City of Riverside
Cultural Heritage Board
SPECIAL MEETING

CERTIFICATE OF APPROPRIATENESS STAFF REPORT

I. CASE NUMBER(S): P13-0889

- 1) **Proposal:** Proposed Certificate of Appropriateness for a new 1,548 square foot single family residence with detached garage on a contributing lot to the Wood Streets Neighborhood Conservation Area that was recently split off from the original lot with an approved parcel map within the R-1-7000-CR (Single Family Residential, Cultural Resources Overlay) Zone and Wood Streets Neighborhood Conservation Area.
- 2) **Location:** 4411 Elmwood Court, located 300 feet east of Palm Avenue.
- 3) **Applicant:** Michael W. Cote on behalf of Riverside Marcus LLC
3975 Madison
Riverside, CA 92504
- 4) **Case Planner:** Teri Delcamp, Historic Preservation Senior Planner
(951) 826-2117
tdelcamp@riversideca.gov

Elevations

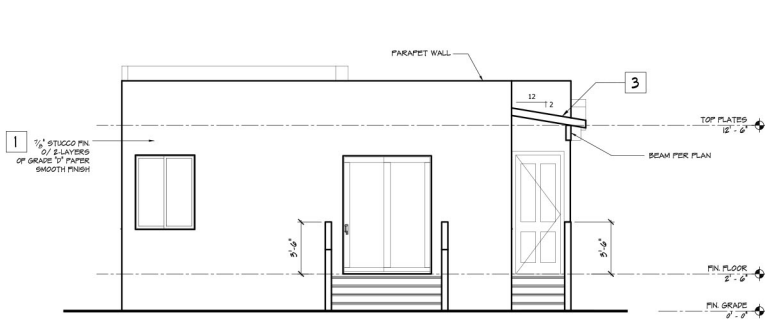
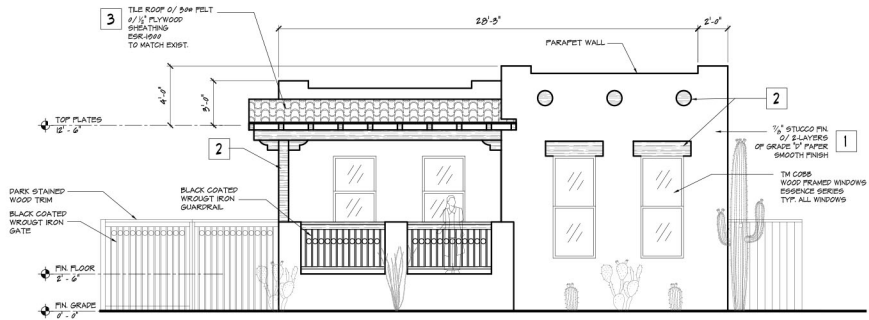
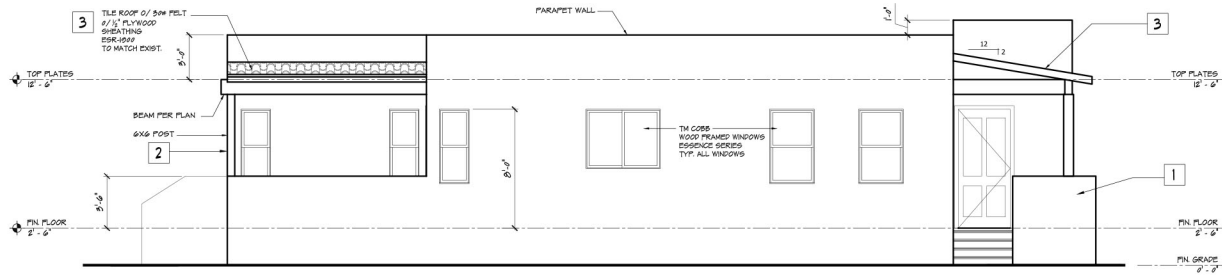
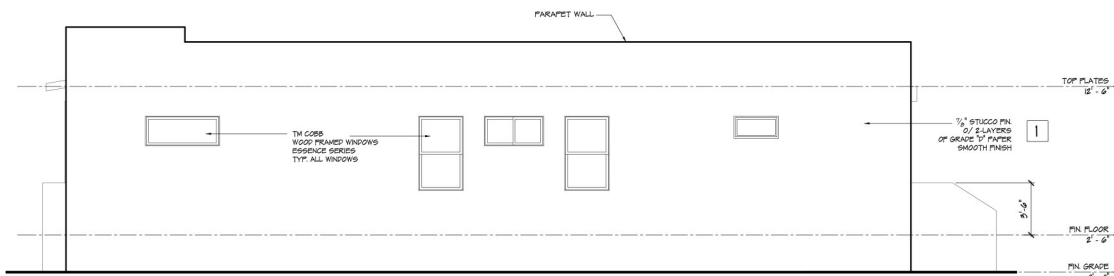
The applicant responded to staff’s inquiry that the owners agree to a condition that requires two-piece, or single barrel, clay tiles instead of the proposed concrete S-tiles. The clay two-piece tiles are more compatible with the historic materials of the NCA and will be more visually consistent with the clay pipe roof vents proposed on the front façade. Staff is also

- b. Plans shall specify that the three circular features below the parapet on the front façade are clay pipe drains/vents.
 - c. Plans shall specify that the material for the two shed roof elements shall be two-piece, single barrel clay tile.

LANDSCAPE PLAN

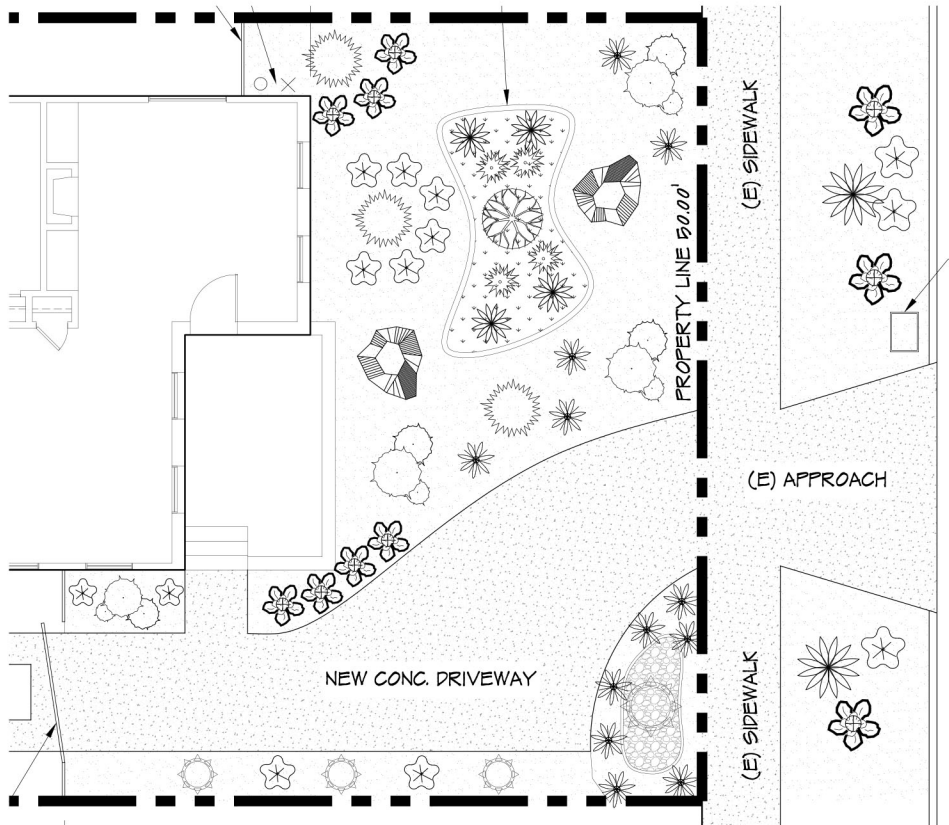
New drought tolerant landscape and groundcover are proposed for the front yard and the parkway that separates the street from the existing sidewalk. A small planter with grass and varieties of kalanchoe succulents is proposed in the center of the front yard, surrounded by decomposed granite with cacti, echeveria succulents and boulders. The parkway will be decomposed granite with echeveria succulents. An existing street lamp and a mature tree are also located within the parkway. An exhibit depicting typical images of the proposed landscape palette is included in Exhibit 6.

6. Prior to approval of the final inspection, the installation of the landscape and irrigation per the approved plans must be complete. Call CHB staff to schedule the final inspection at least a week prior to needing the release of utilities. Upon final inspection of landscaping, if staff finds that the amount of landscaping is insufficient, staff will require additional plants/groundcover consistent with the approved palette.
